U.S. NUCLEAR REGULATORY COMMISSION

Report Nos. 50-317/85-16
50-318/85-14

Facility Name: Calvert Cliff Nuclear Power Plant, Units 1 and 2

Inspection on June 24 - 28, 1985 (Report Nos. 50-317/85-16; 50-318/85-14)

FIGURE 1
COMBUSTION ENGINEERING POST ACCIDENT
SAMPLING SYSTEM

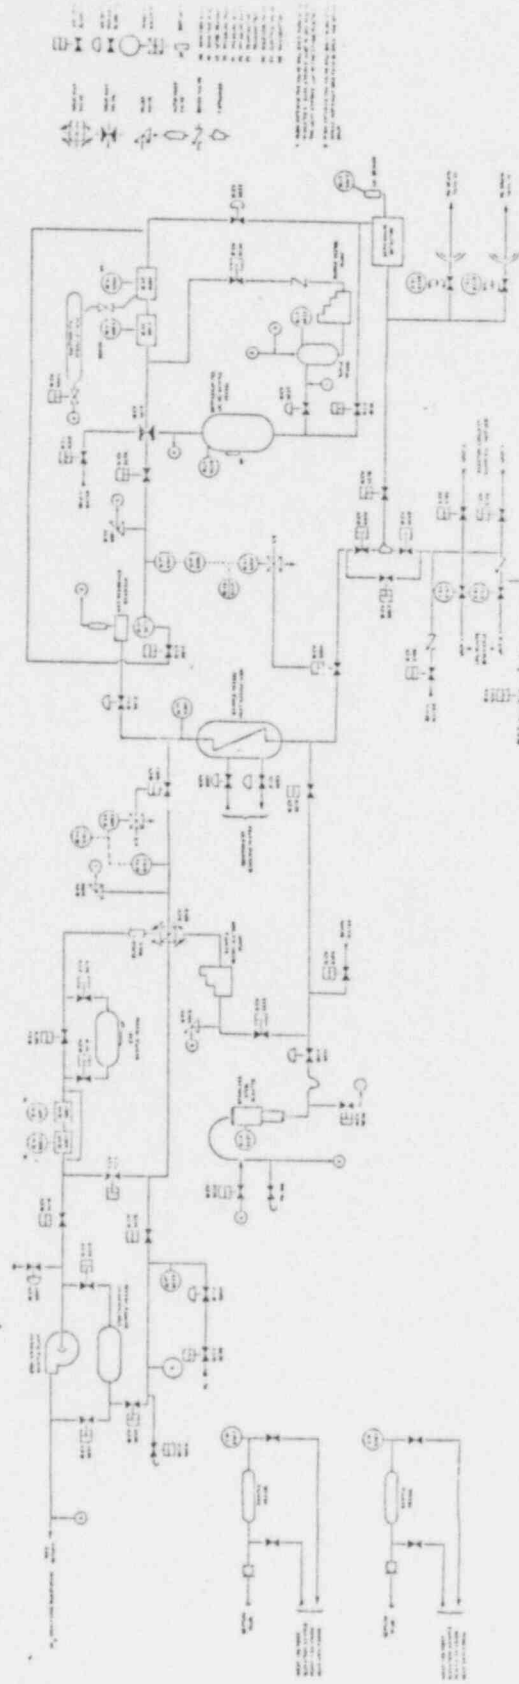
Based on a review of the licensee's maintenance records and discussions with cognizant personnel, it was observed that there have been continual problems with the system including leaking valves, valves which have been inoperative under system pressure, inoperable system components, and erroneous instrument indications. As a result, the system has not been available for developing and verifying procedures, and subsequent training of personnel.

No fully integrated or complete test of the system's capability to collect and analyze samples had been conducted. For example:

1. The Technical Specification 3/4.7.13 require that the system be able to collect a reactor coolant sample from the hot leg and the Low Pressure Safety Injection (LPSI); and a containment sump sample via the LPSI. Based on the data presented, only sample acquisition from the Unit 2 hot leg had been tested on June 10, 1985. At the time of this inspection documented tests to establish that samples can be collected from the LPSI at low reactor coolant pressure had not been performed.

2. The system's analytical instruments have not been tested using the NRC recommended standard test matrix solution to determine possible chemical interference that might affect analytical capability.

3. The system had not been tested to demonstrate the effectiveness of the method of sample dilution. Sample dilution capability was found on June 10, 1985 to be insufficient to permit reactor coolant chemical and isotopic analyses within the tolerances specified in licensee submittals.

4. Only one test on June 10, 1985 has been documented to establish the accuracy of the in-line analysis of radionuclides. This test revealed that just prior to the inspection, an analysis error of a factor of 80 for some radionuclides could be expected, and the NUREG-0737 required factor of 2 could not be generally achieved.

On June 26, 1985, an exercise of the CE-PASS was attempted, but could not be performed, in that:

1. The Emergency Procedure (ERPIP 4.4.7.6) provided for the operation of the system had not been updated to agree with the current design configuration. As a result, it could not be used. Subsequently, the technicians were required to rely on the surveillance procedure (RCP-1-407) in an attempt to operate the system.

2. The licensee was unable to sample from the Unit 2 Hot Leg. It was later found that the jacking bolt to the Unit 2 Hot Leg sample acquisition valve, 2-CV-5105, had been previously tightened down on the valve in an effort to repair a chronic seat leakage problem. The valve was not tested following this "repair". The licensee's subsequent evaluation indicated that the jacking bolt had effectively locked the valve in a closed position, preventing any operation.

3. Further testing of the system was prevented when CE-PASS sample exhaust valves 1-SV-6529 and 2-SV-6529 failed to function, preventing sample flow.

FIGURE 2

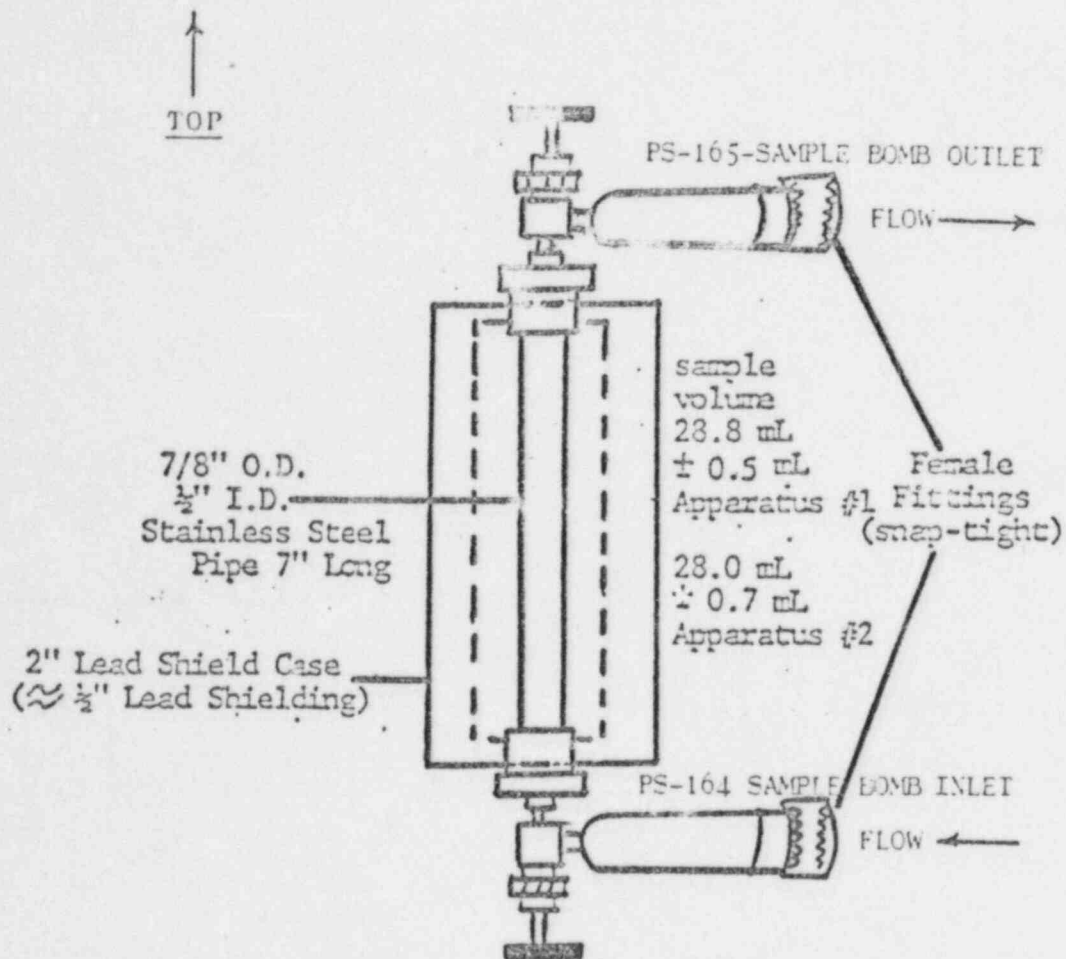
3. During a test of the NSSS sink/PASA method the operator experienced a considerable difficulty in the extraction of the sample from the bomb. Undiluted reactor coolant was forced out of the top of a burette in the PASA assembly, with a consequent loss of sample. This could have resulted in significant personnel exposure, and facility and equipment contamination in an actual post accident condition.

4. The PASA assembly was not structurally sound. The operator had to hold the assembly in place in order to apply enough force to attach the sample bomb. Additionally, all of the sample containing components of the PASA assembly, excepting tubing, were laboratory glassware. Such glassware could be subject to breakage in a post accident condition rendering the system inoperable and subjecting personnel, facilities and equipment to significant contamination.

5. The NSSS sink/PASA assembly was not provided with any shielding to reduce personnel exposure (excepting 1/2" of lead on the sample bomb). Additionally, the system has no provisions for remote operation or handling of components or processes; and required considerable direct personnel contact with components and valves that contained undiluted reactor coolant. With the exception of a shield wall and wide view mirror assembly to observe coolant flow in the NSSS sink, and a cart with lead bricks to transport the sample bomb to the radiochemistry laboratory, the method did not employ provisions to reduce personnel exposure. Though the procedure (ERPIP 4.4.7.4) did

FIGURE 3

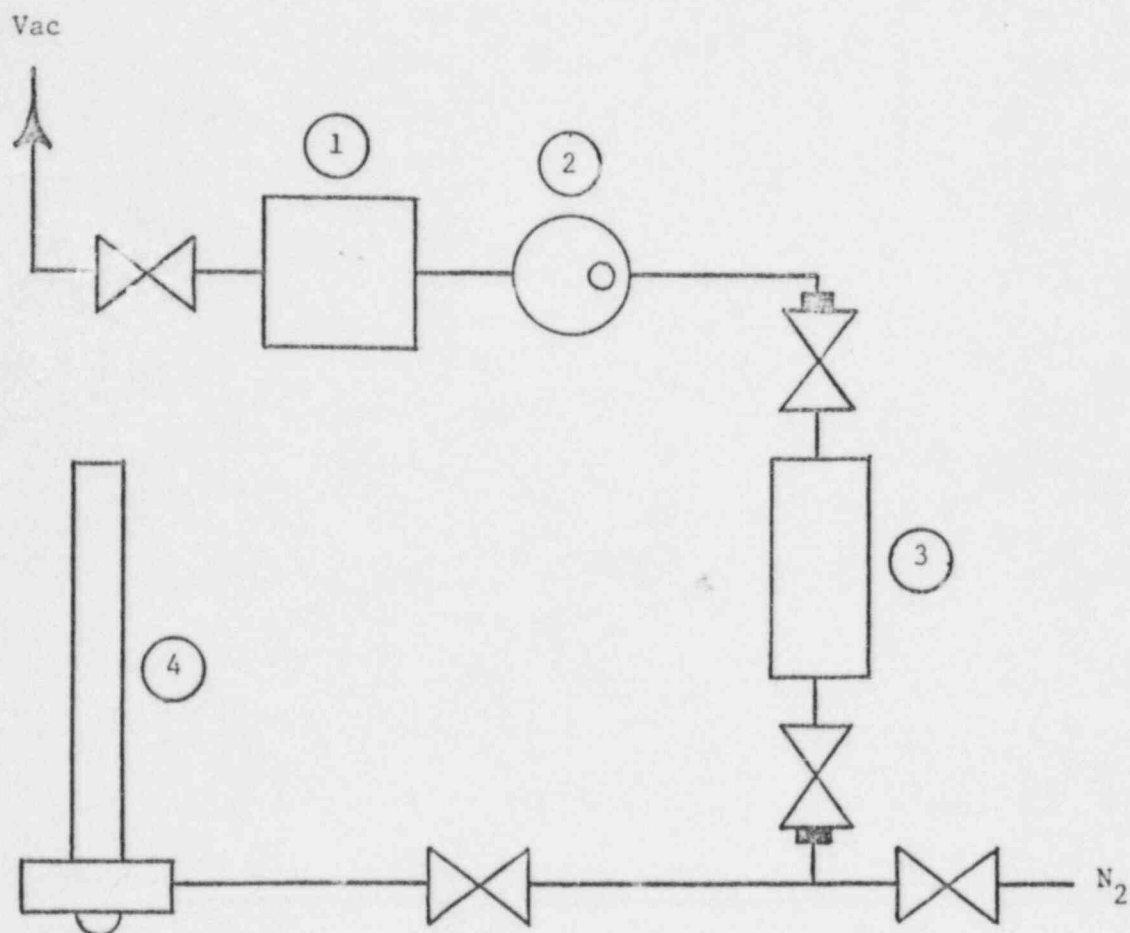
6. A time and motion study to demonstrate that a sample could be collected and analyzed without exceeding GDC 19 dose criteria has not been conducted. It is unlikely that, without significant upgrading of personnel training, procedures, and ALARA considerations, the method would provide a realistic and workable option in the post accident condition.
7. The analysis procedure (ERPIP 4.4.7.4) did not contain provisions for the analysis of hydrogen and pH for post-accident samples.
8. The position indicator for the sample line isolation valve 5467 produced erratic indication. Further, the valve could not be closed after sample acquisition at the NSSS sink.
